ADDENDUM TO THE CONTRACT

Gastineau Elementary School Renovation

Contract No. E11-137

ADDENDUM NO.: TWO

SHEET #
A1.4

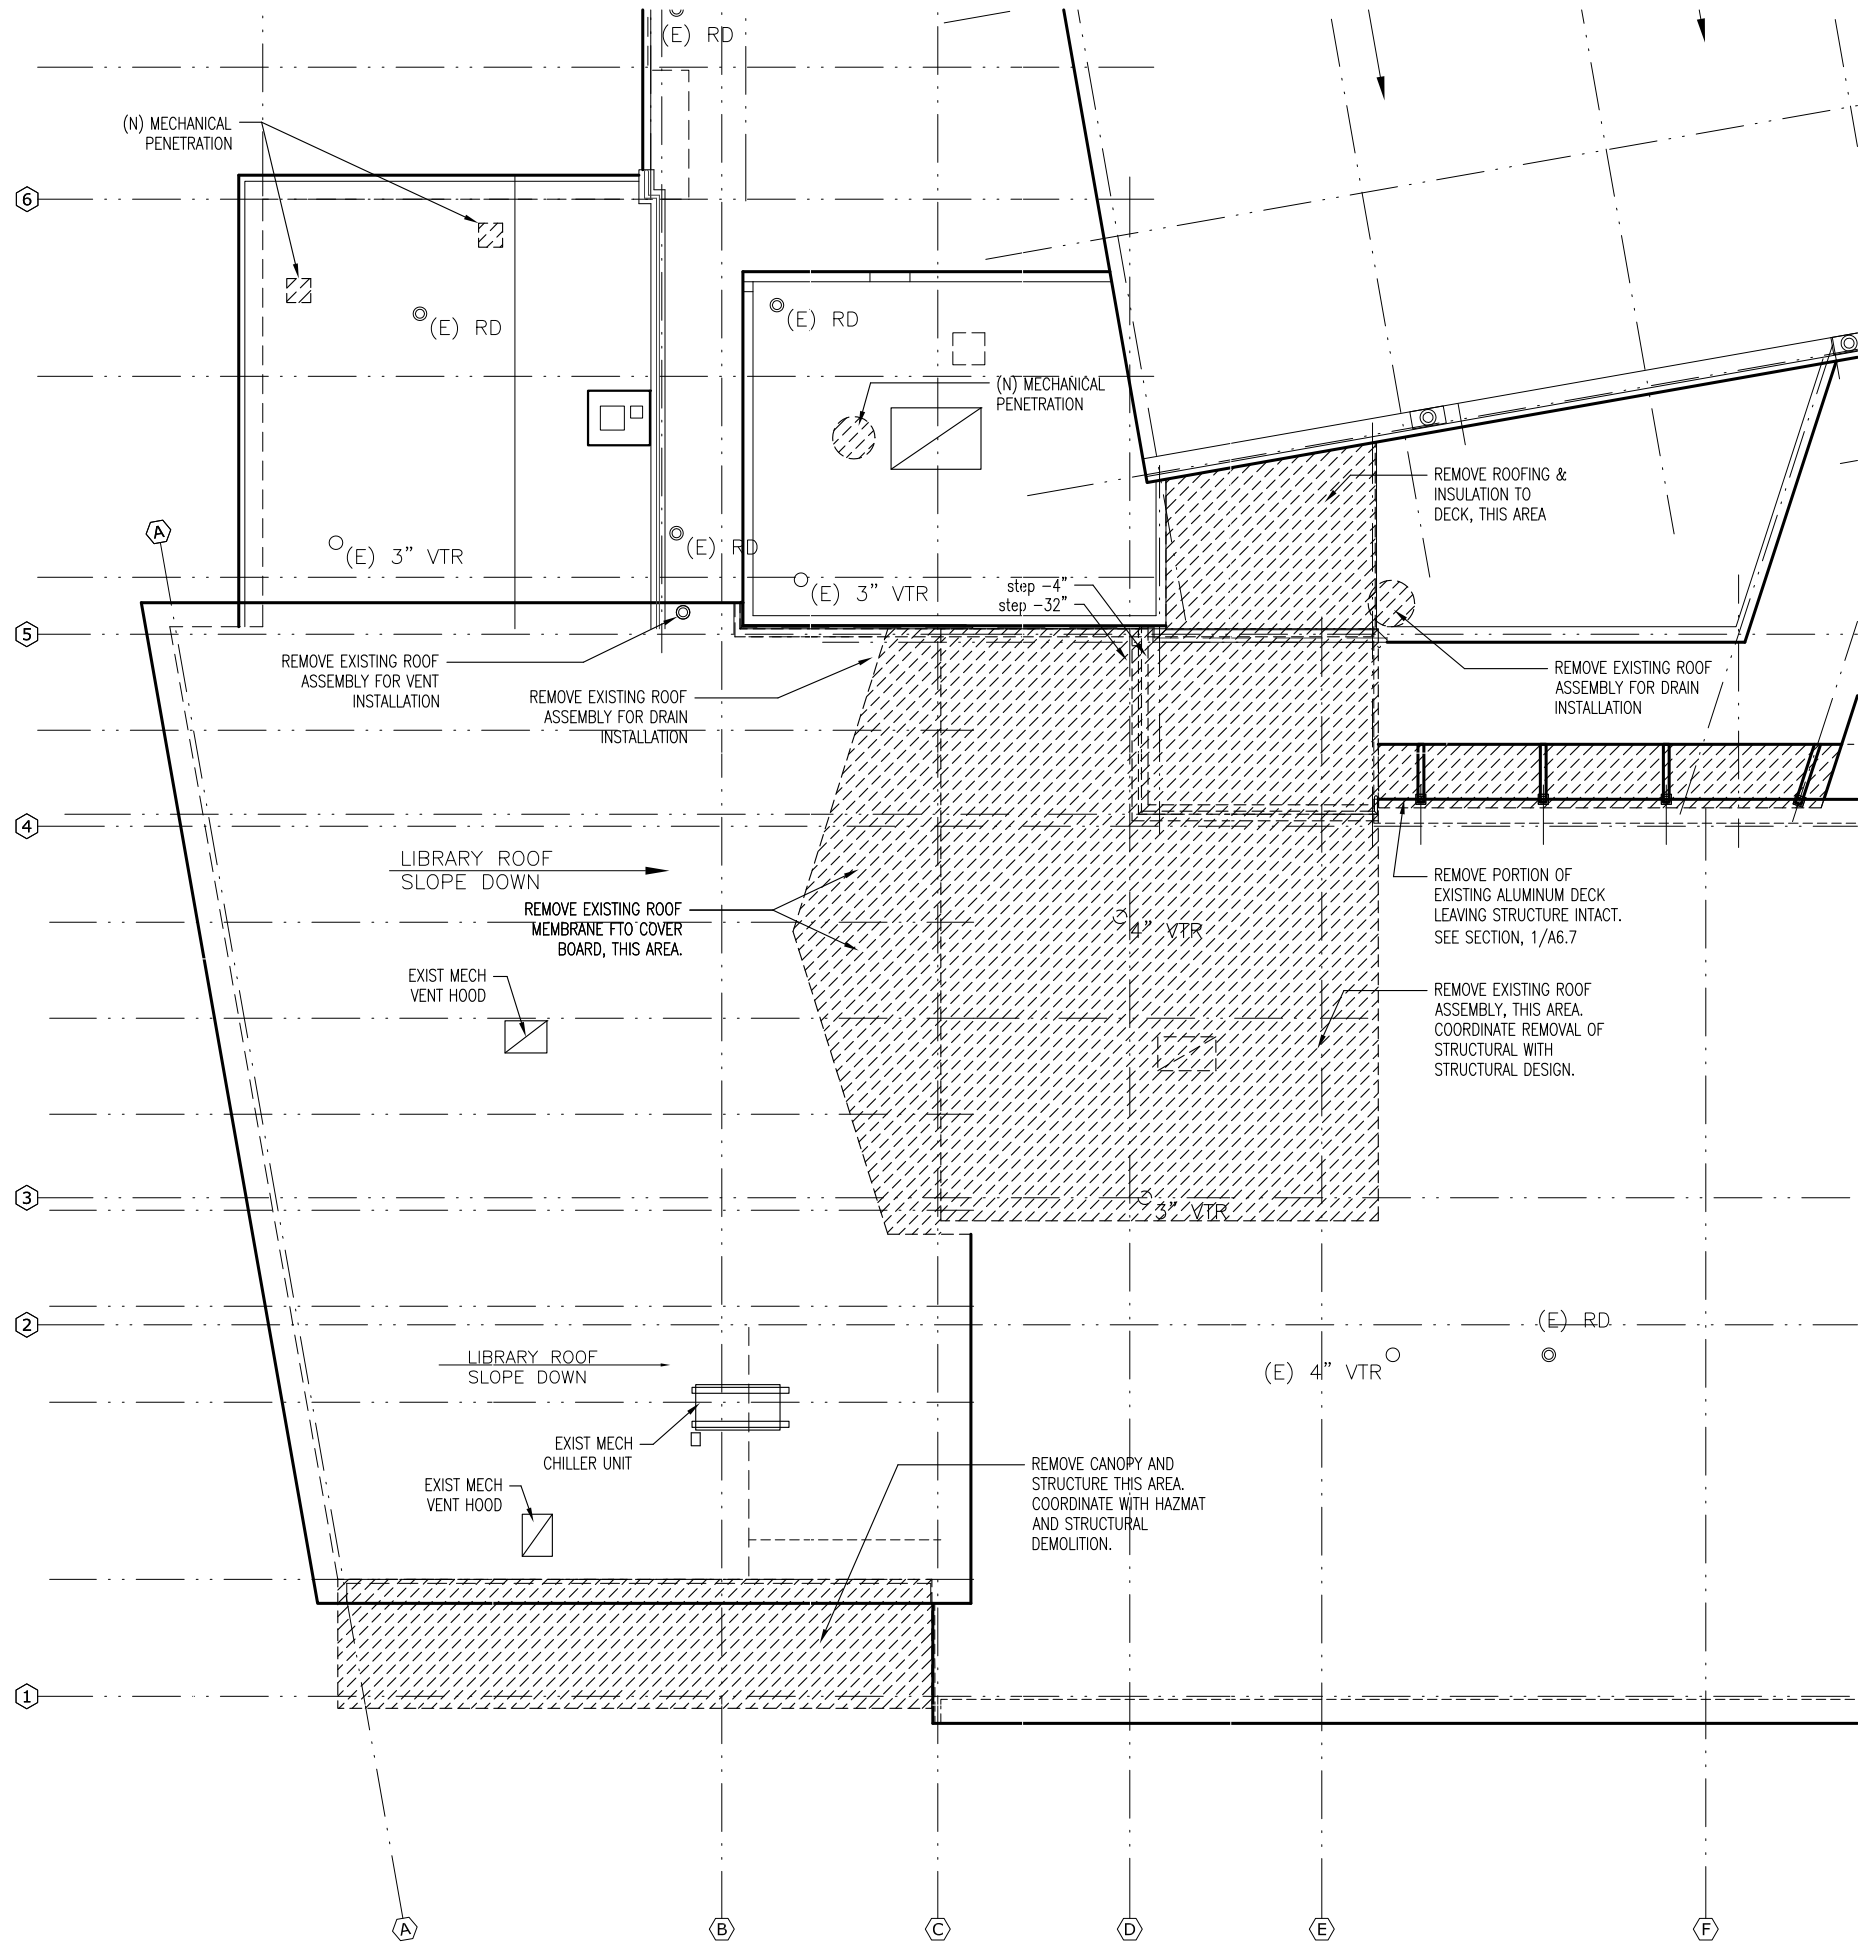
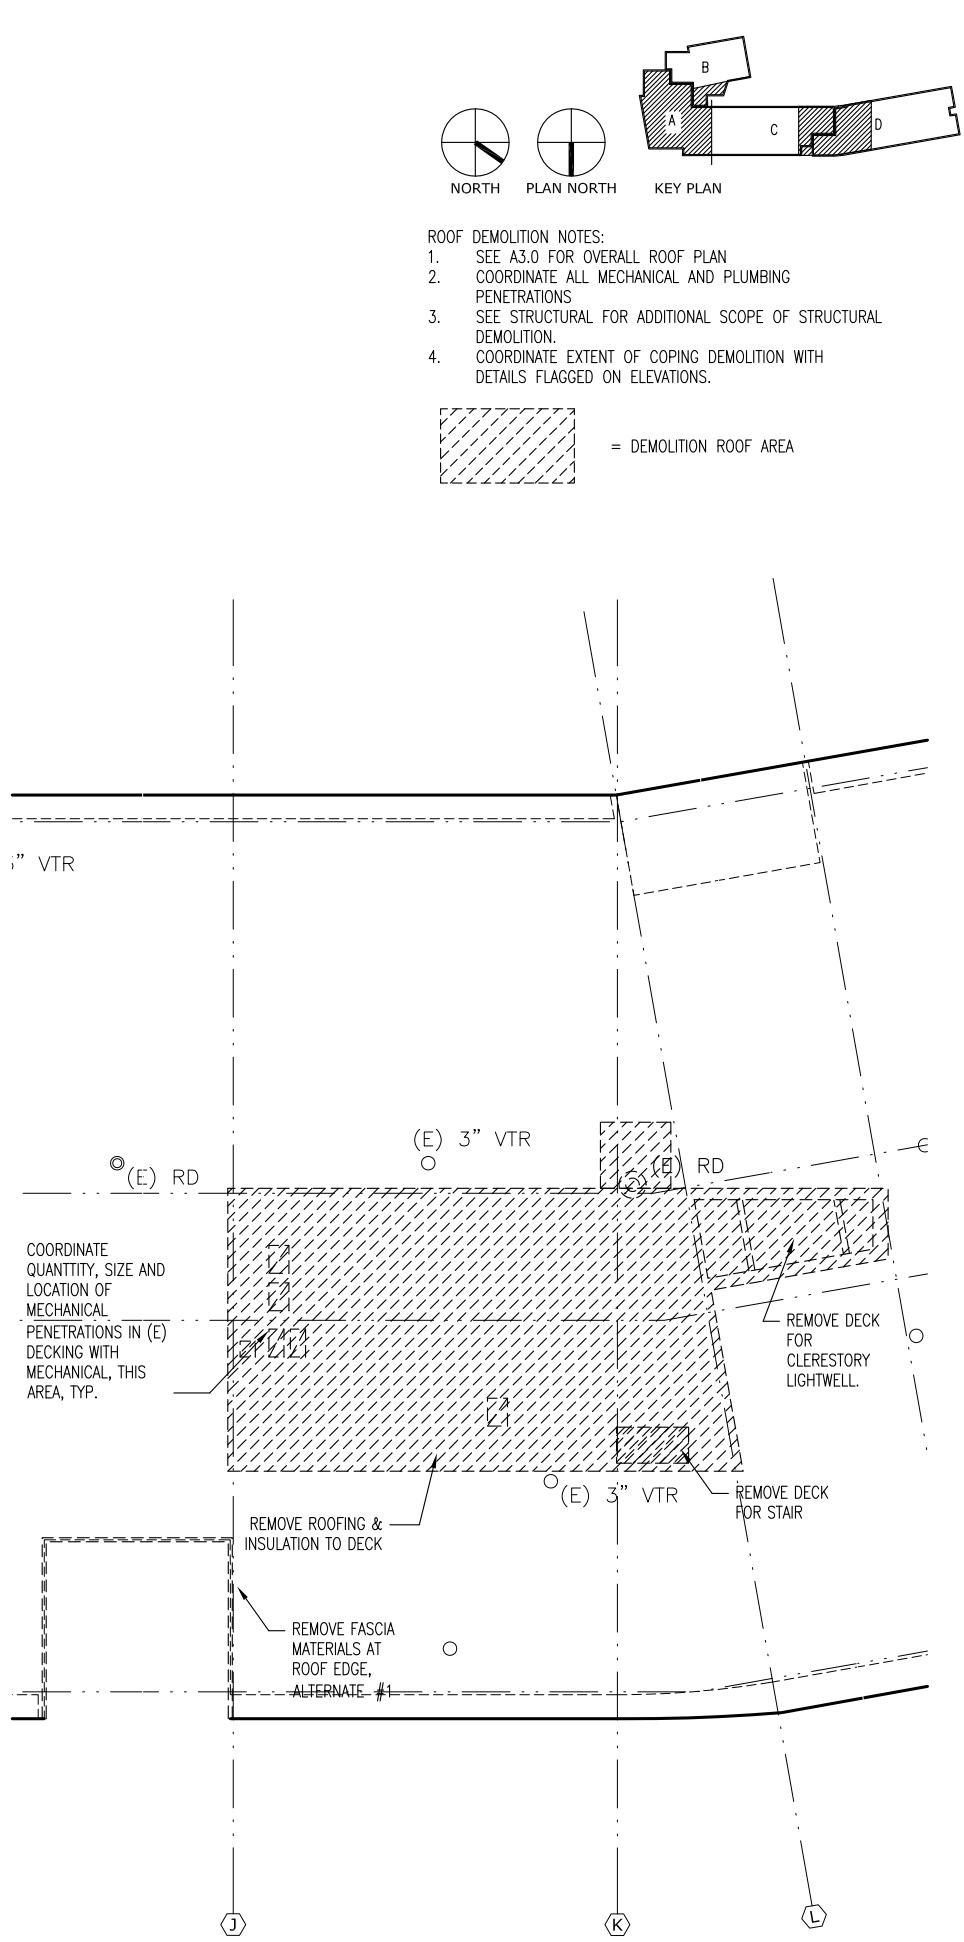
- Item No. 18 A1.4: Delete Sheet A1.4 and replace with attached sheet A1.4. The changes eliminate new construction notes inadvertently placed on this demolition plan, and show demolition for mechanical where mechanical does not require demolition.

SHEET #
A2.0

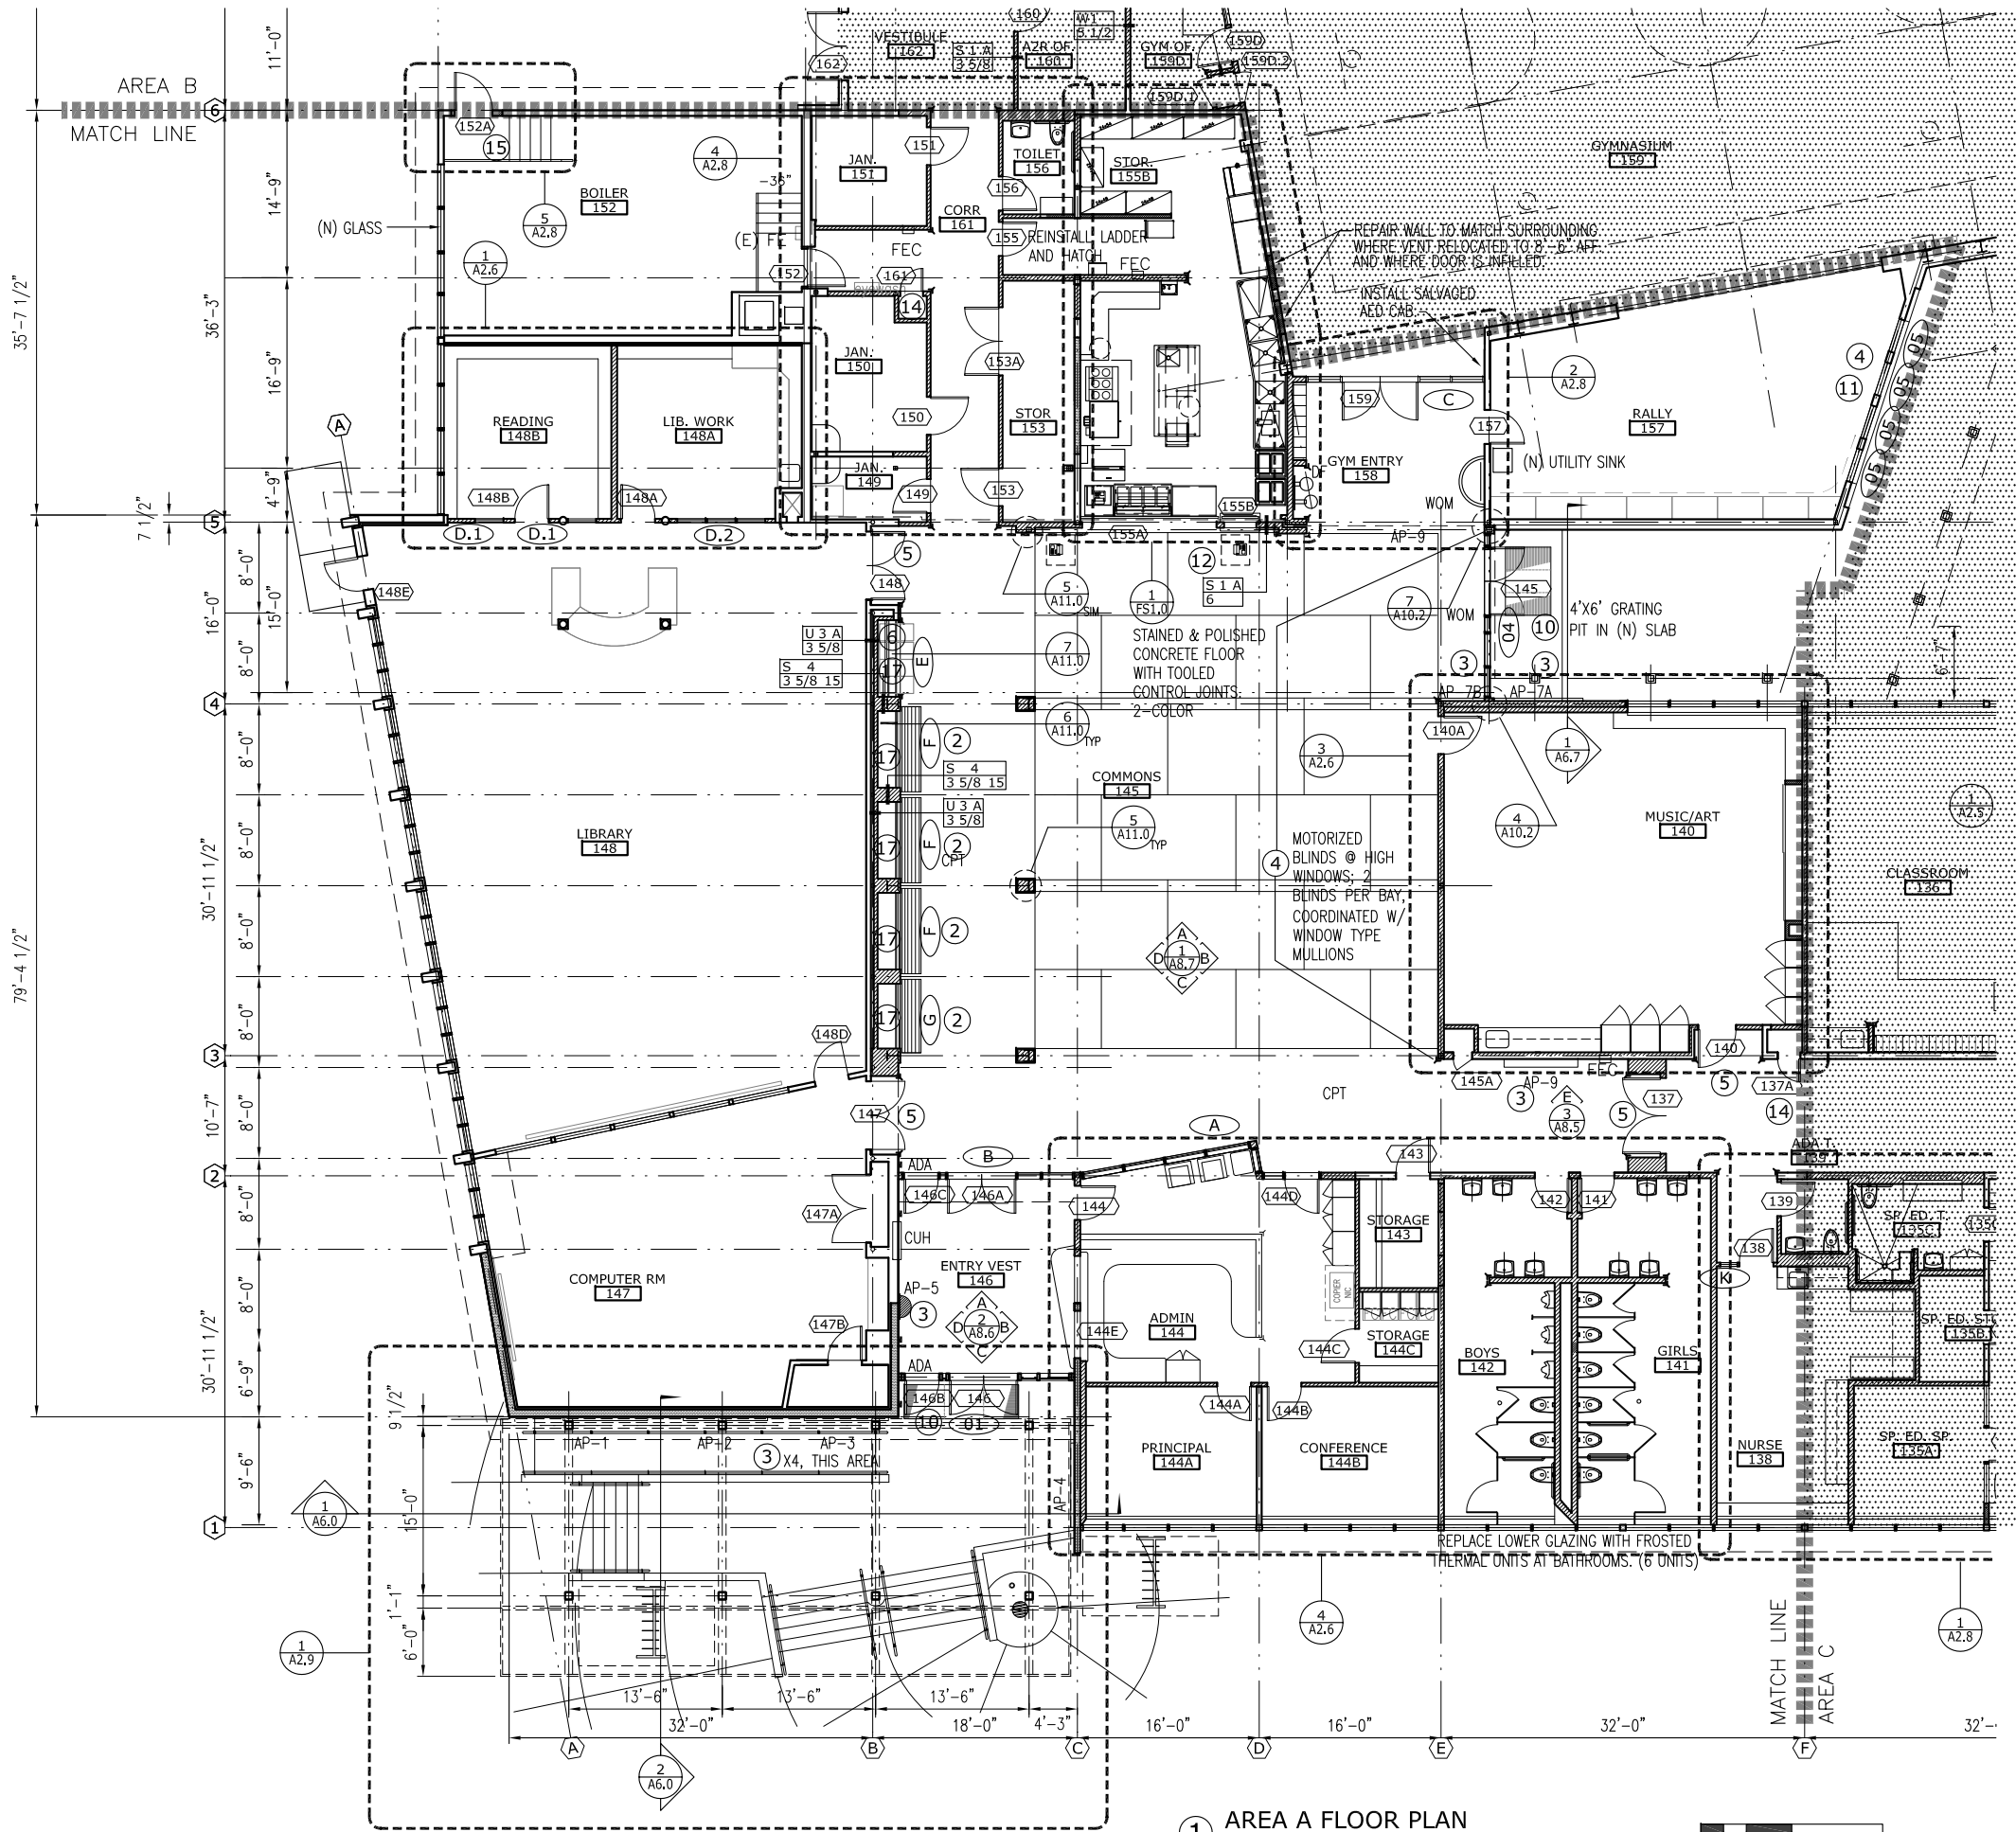
- Item No. 19 A2.0: Delete Sheet A2.0 and replace with attached sheet A2.0. Modifications relate to Key notes 7 and 8. Line-work clarity is improved for half-size drawings.
